PARTS Bulletin

Parts Bulletin #1 May 2016

Subject: Return line for SM4T series

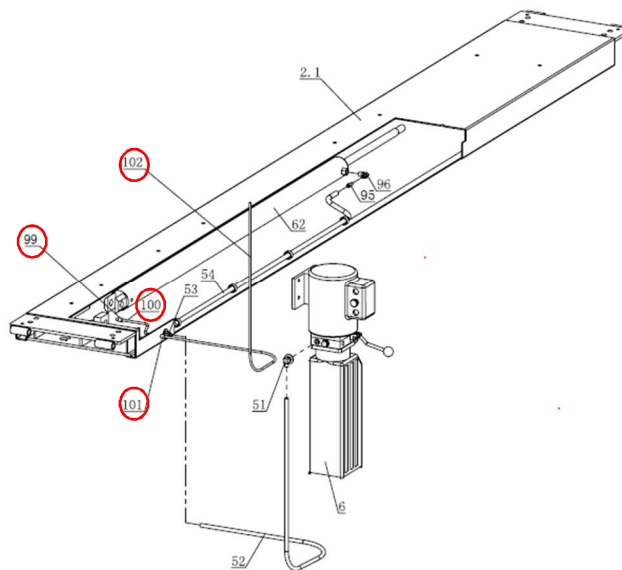
In order to solve the trouble caused by small leaking of the cylinder and to prolong the lifetime of the cylinder, we design the return line for SM4T series. SM4T series contains the lifts below: SM4T, CR4T, RSM4T and DSM4T.

Part number: 99, 100, 101, 102 are new added parts for the lift.

For the lifts produced after 2015, the parts needed are already packaged with the lift.

For the lifts produced before 2015, if the cylinder failed, the lift will need the SM4T feedback line kit and the tank for the PU with elbow to replace the failed cylinder and install the return line for the lift. The serial number is necessary for checking which PU we use for lift and send the right tank.
